CASTLE CEMENT LTD, KETTON WORKS, KETCO AVENUE, KETTON, RUTLAND, PE9 3SX

Regulation 25 Response

PLANNING APPLICATION 2024/0066/MIN

December 2025

Figure 1 - Extract from DMP showing proposed monitoring locations.

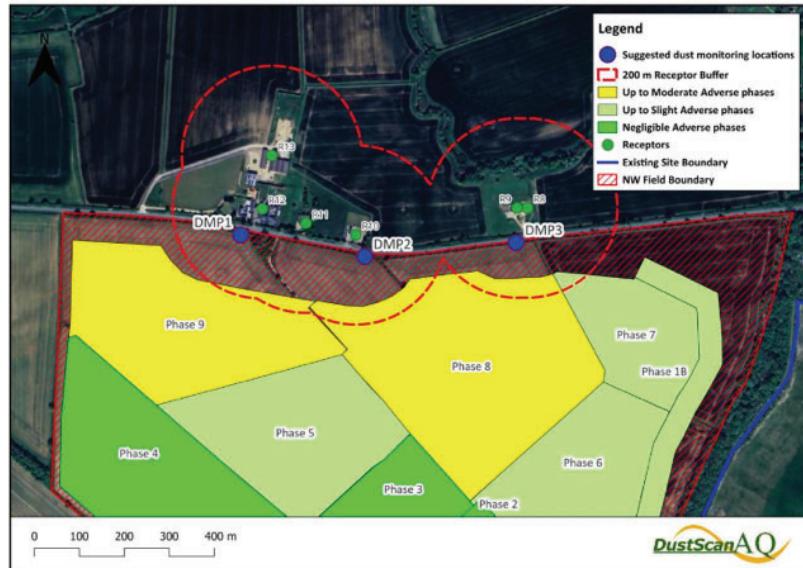
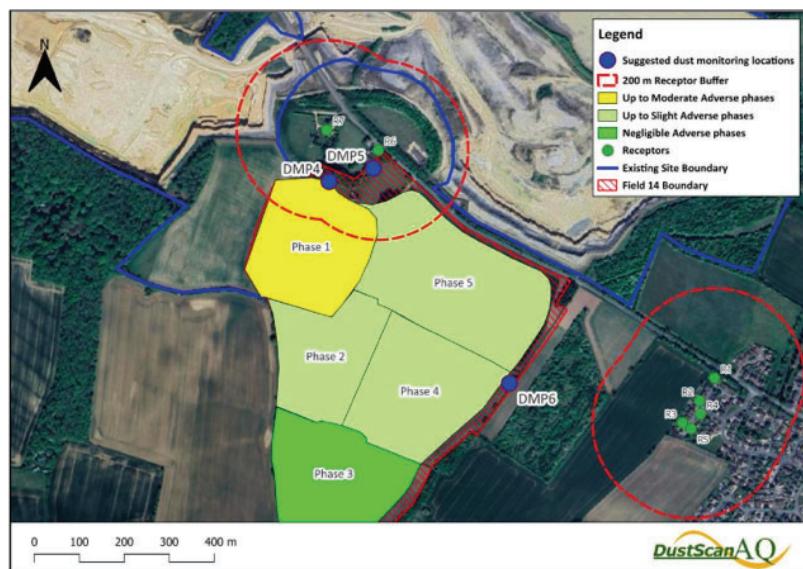
36. The Applicant has been monitoring its dust levels at Ketton, for over 20 years as part of its current operations. If planning permission is granted for this application, the revised dust management plan will be employed and result in updated equipment and monitoring locations to reflect the quarry extension and receptors affected. Figure 1 below (Figures 4.3 and 4.4 from the DMP) show the proposed monitoring locations.

37. In addition to the existing dust monitoring gauges used on Site, it is proposed to install more modern, automated monitors that collect a wider range of data and have the ability to provide real-time analysis. As well as traditional fugitive dust, they will also monitor PM₁₀ levels and issue an automated alert level of 190_{µg/m³} over a 1-hour interval based on practice guidance for the construction industry.

Figure 4 - Original Layout for Paradise Field

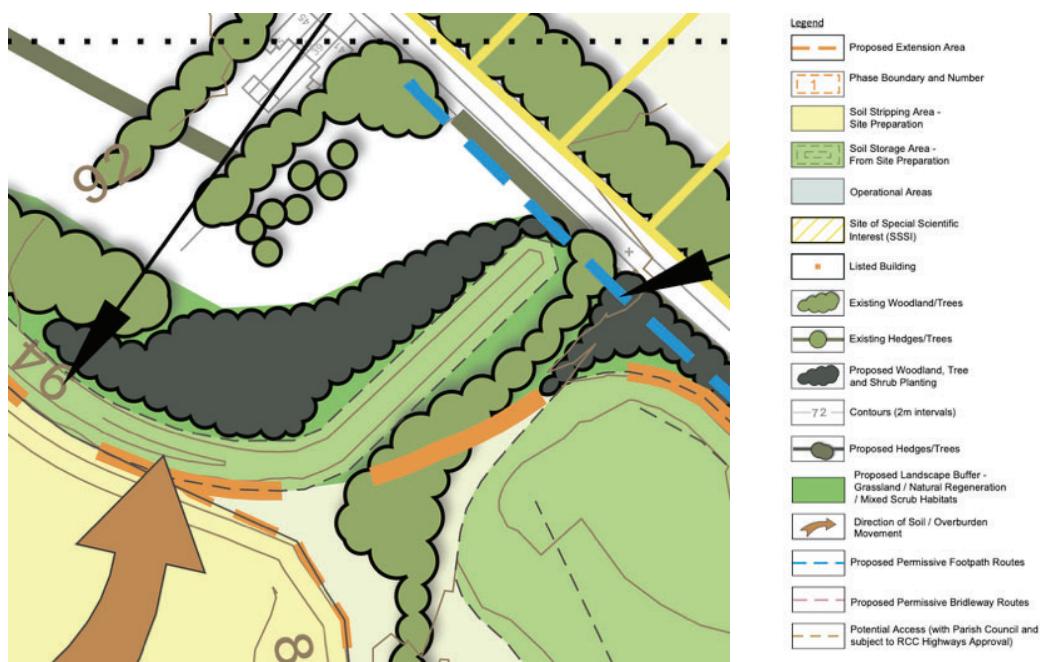
90. In the original design (Figure 4), the bund sat in Paradise Field with new woodland planting (shown in dark green) covering the ridge and furrow between the bund and Wytchley Warren Cottages. The original limit of extraction (dashed orange on Figure 4) cut across the Southern corner of Paradise Field. Most of the Giant Redwoods were to be removed under that extraction limit.

91. The new limit of mineral extraction (Figure 5) (dashed orange) has been pulled southwards in Paradise Field (compare with Figure 4). Scattered planting (aligned NW-SE) along the northern edge of the realigned bund and extraction will screen the workings from Wytchley Warren Cottages and Empingham Road. The proposed soil storage area has moved to the SE of the linear woodland containing the Giant Redwoods. This will retain more of the Giant Redwoods.

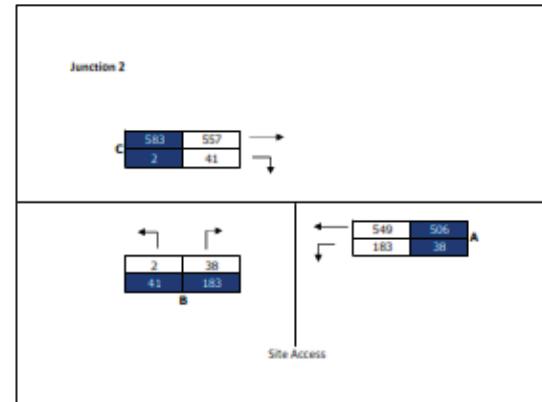
There is a high risk of dust emissions from transport on unpaved roads unless appropriate mitigation measures are applied. Dust may be generated from downward-blowing exhausts and cooling fans as well as air turbulence caused by vehicle movements, so only mobile plant that avoids such risks with upward or sideways exhausts should be used.

Site haulage can be a significant source of dust, particularly over longer haul distances when speeds tend to be higher and there is an added requirement to maintain a smooth well-drained surface. The majority of haul roads on site will be located well away from site boundaries so the likelihood of dust generated by on-site transportation travelling off-site from these areas will be lessened on account of the horizontal distance to the quarry rim.

The residual source emissions from on-site and off-site transportation after mitigation is applied were therefore considered to be Medium for both Field 14 and NW Field.
